# Groundwater Transfer Review Summary Form

Transfer/PA # T- 13657

Application: T-13657

Applicant Name: Red Rock Water, LLC

**Hydrograph 1.** The colored dashed lines indicate the decline trigger level for the corresponding well. CROO 24 is a state observation well with quarterly measurements taken by OWRD staff that shares similar groundwater elevation and trend as the permitted wells.

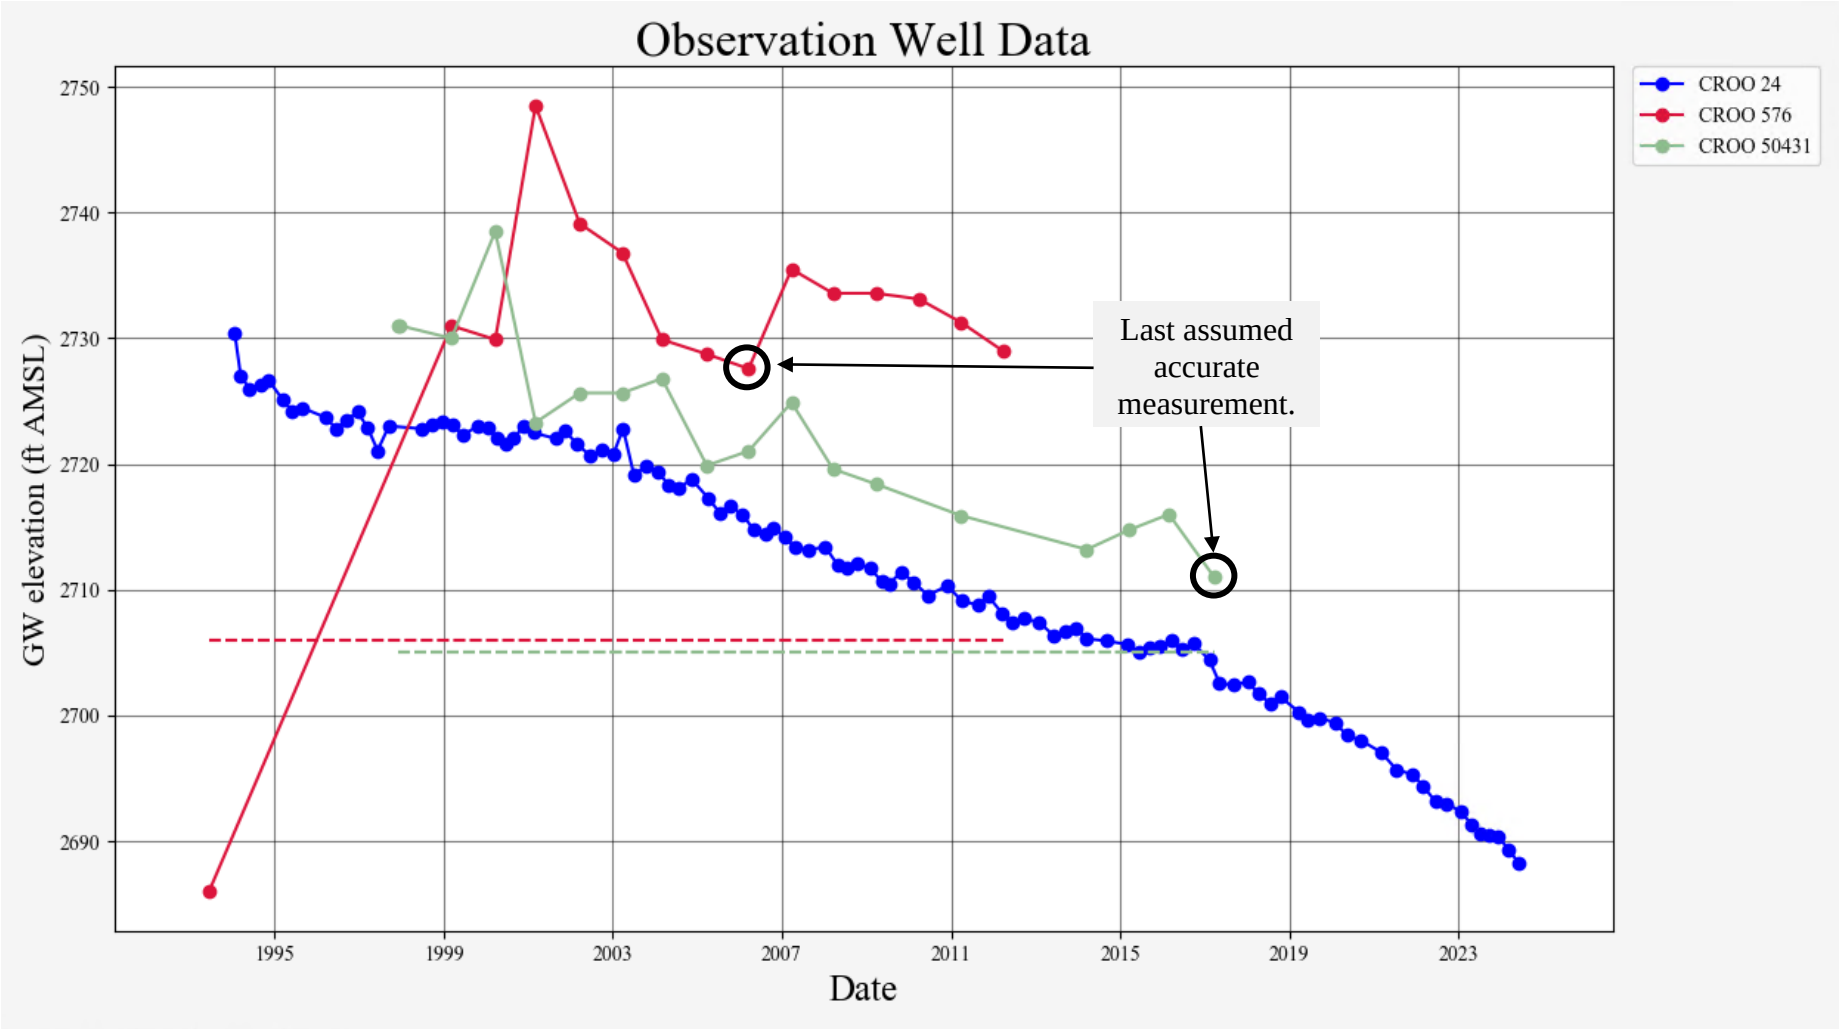
Certificate 85995 Decline Condition Status: Hydrograph 1 and the decline threshold analysis table below summarize the reference levels outlined in the originating certificate, the most recent water level data in the authorized POAs, and the water level changes in adjacent observation well CROO 24. Considering the measurement method (airline) and apparent fluctuations of submitted permit condition water levels, there are no accurate measurements for CROO 50431 since 2017 or in CROO 576 since 2006. CROO 24 is located approximately 4 miles SSE from the applicants wells. and its groundwater elevations and trend track closely with the applicant's wells. Hydrograph 2 shows that CROO 24 is the most appropriate proxy for water level fluctuations in CROO 50431 and CROO 576. **The decline threshold table below indicates that CROO 50431 and CROO 576 has likely exceeded their respective permitted declined thresholds.** As per OAR 690-380-0010(2)(d), the proposed changes may meet the definition of enlargement because water may not be legally available at an original point of diversion.
